GROUNDWATER PROTECTION STUDY

Prepared for:
Virgin Town
114 Mill Street
P.O. Box 790008
Virgin, UT 84779

Third Party Comment & Review Letter Correspondence

RE: Virgin Town Groundwater Protection Study - Peer Review Response

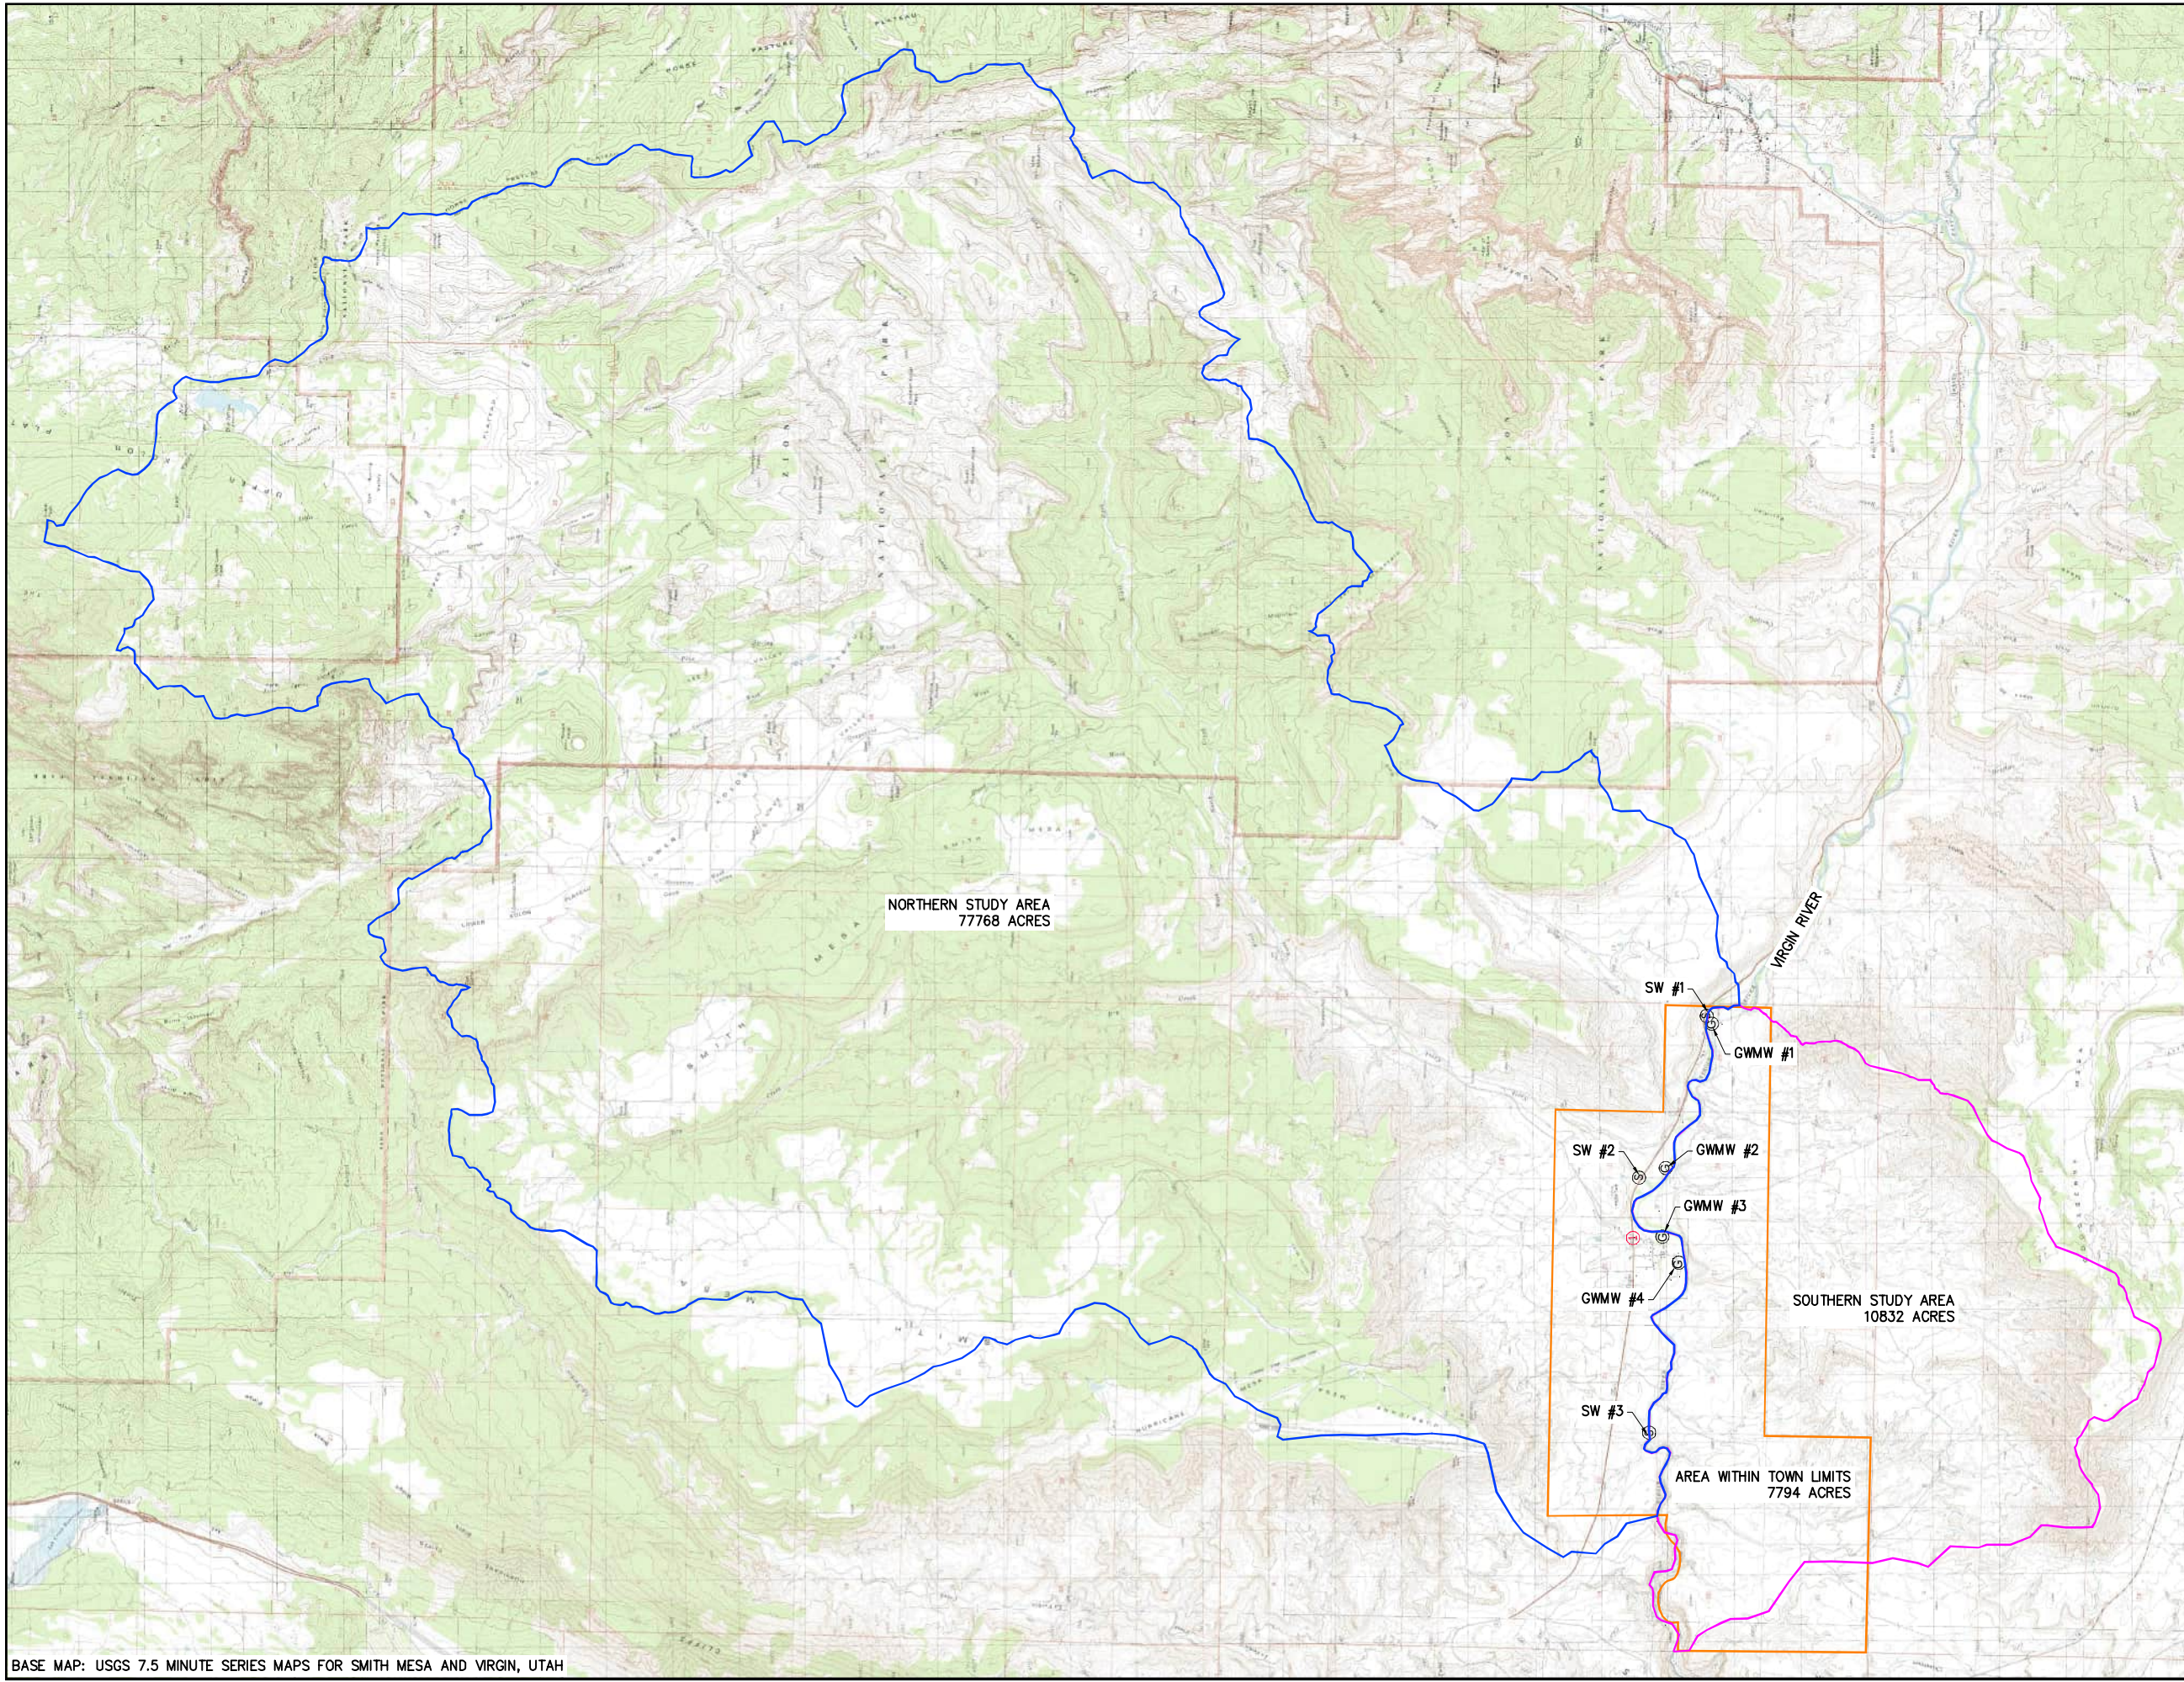
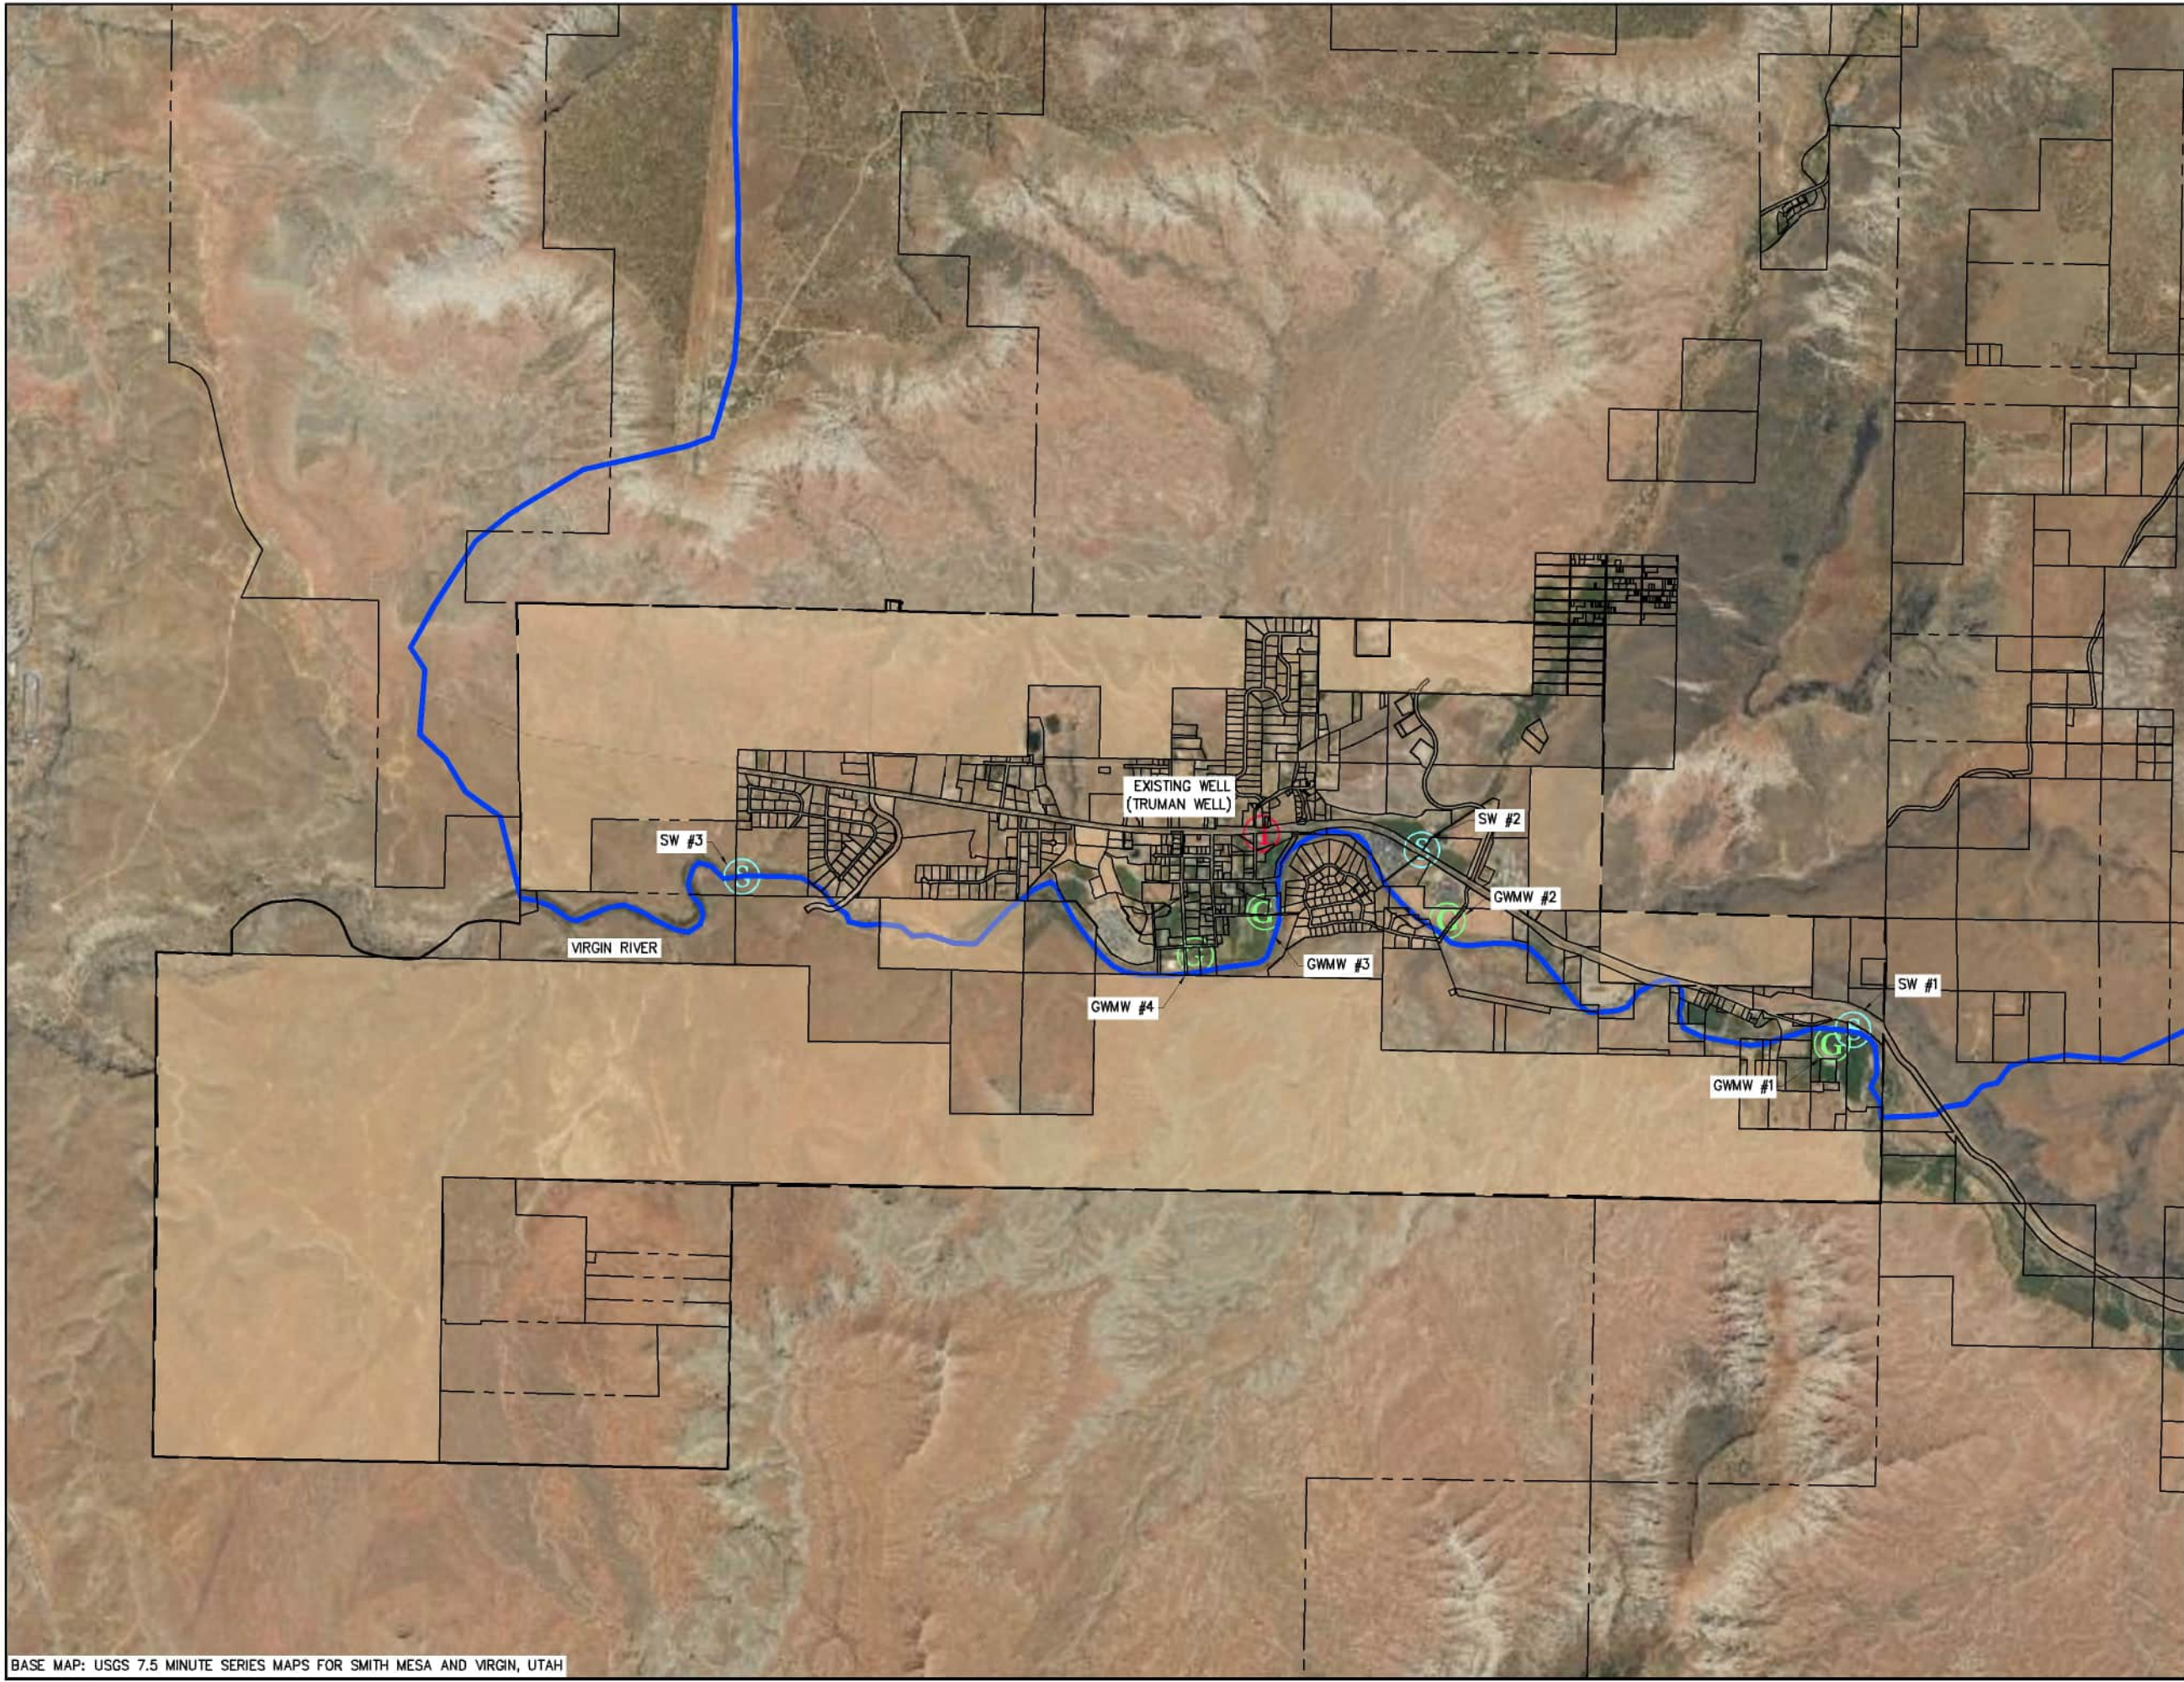
1. Consider addition of focus map showing more detail on sampling locations. It is difficult to make out surface water vs. groundwater symbols.

Response: An additional Figure 1a has been provided on a 1"=1,000' scale so that the sampling locations can be more easily determined.

SEI NO. 09817	DESIGNED DY	DRAWN DY	CHECKED DSA	SHEET NO. 04 of 06	FIG. 4
------------------	----------------	-------------	----------------	-----------------------	--------

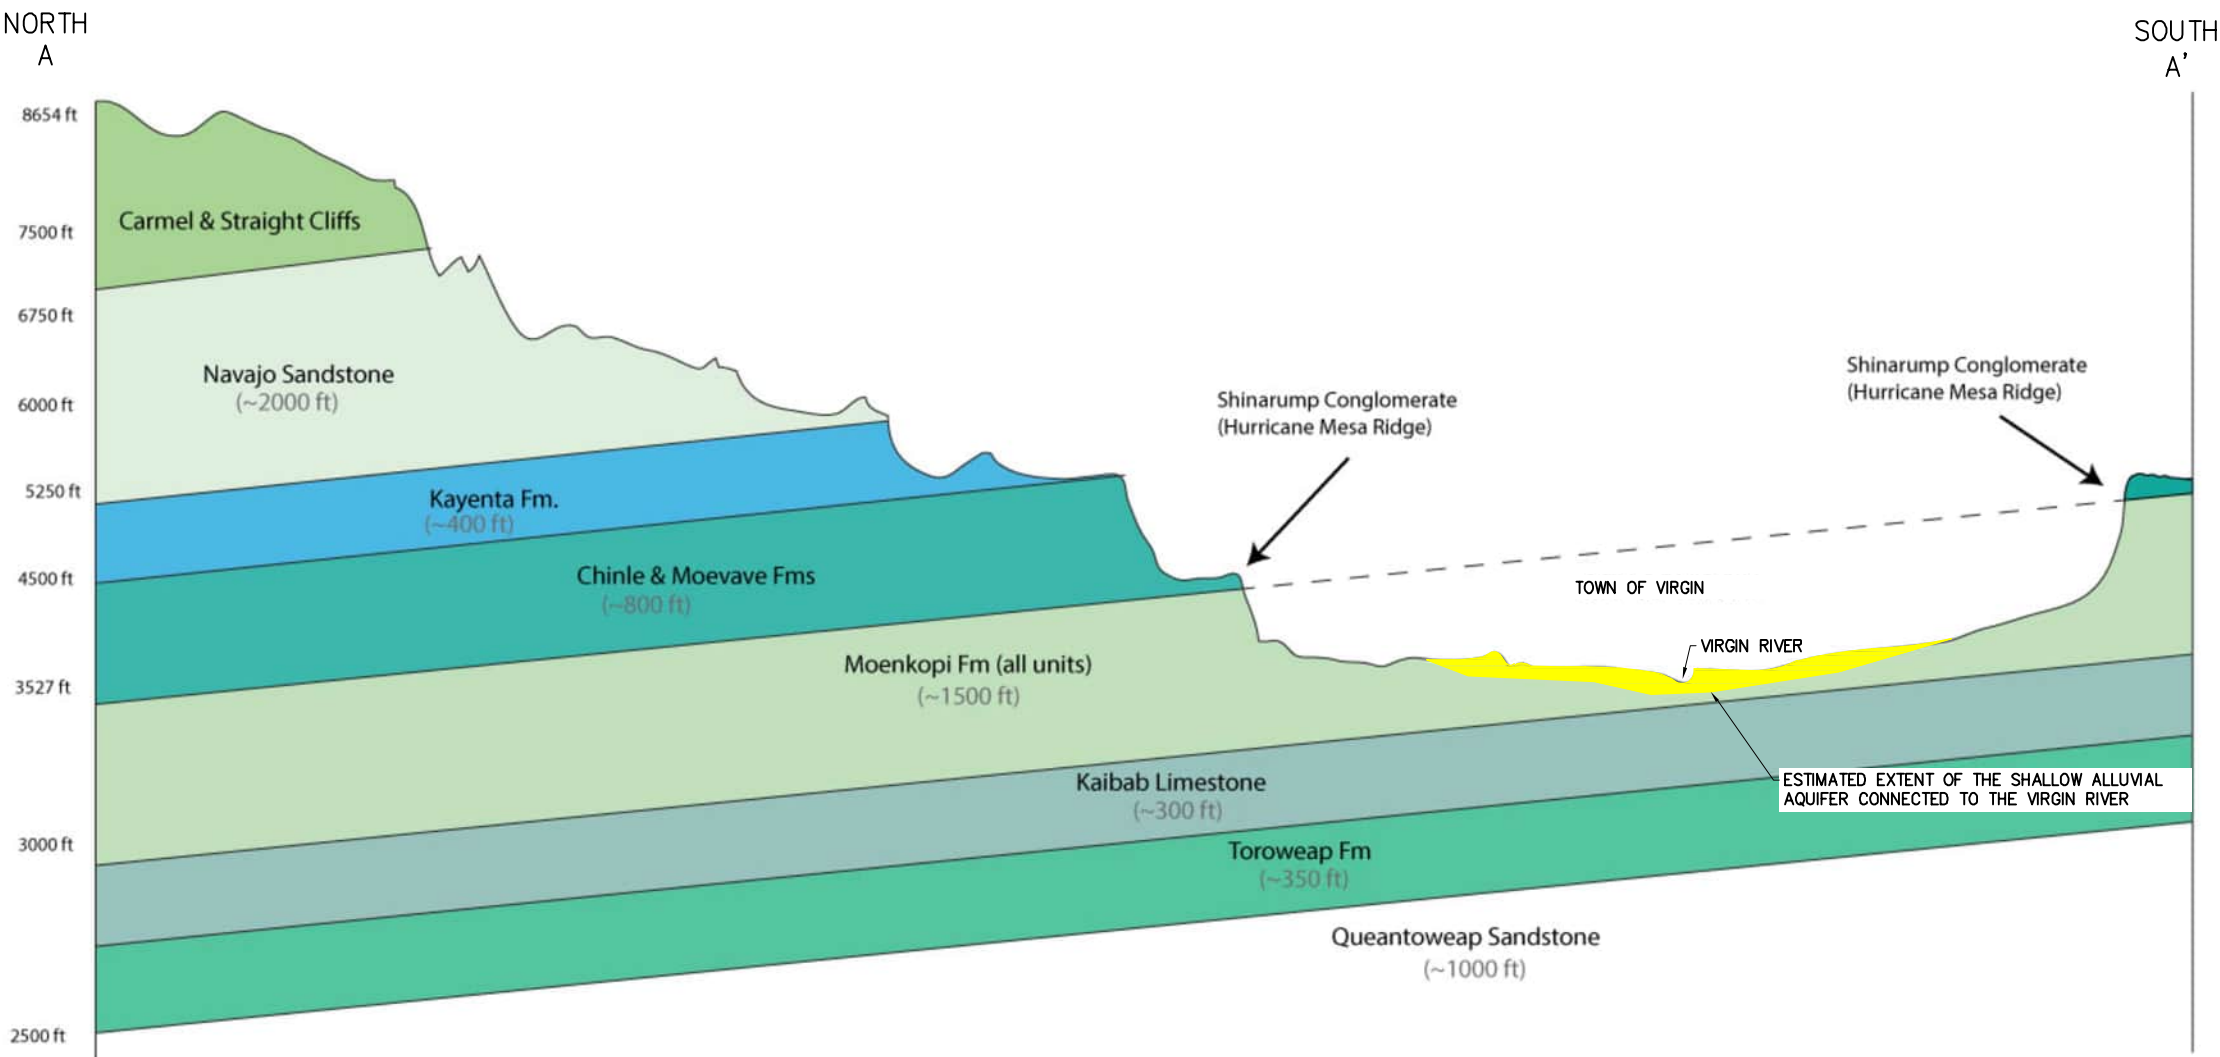
1. Show the alluvial aquifer unit on the cross section. It is unclear why the exposed units are different on the cross section compared to the geologic map.

Response: Figure 4 has been revised to show the approximate extents of the alluvial aquifer that may be connected to the Virgin River.

The cross section shown in Figure 4 is of the Virgin Quadrangle, provided by the UGS. The geologic map shown in Figure 2 is from the St. George Quadrangle, also provided by the UGS.
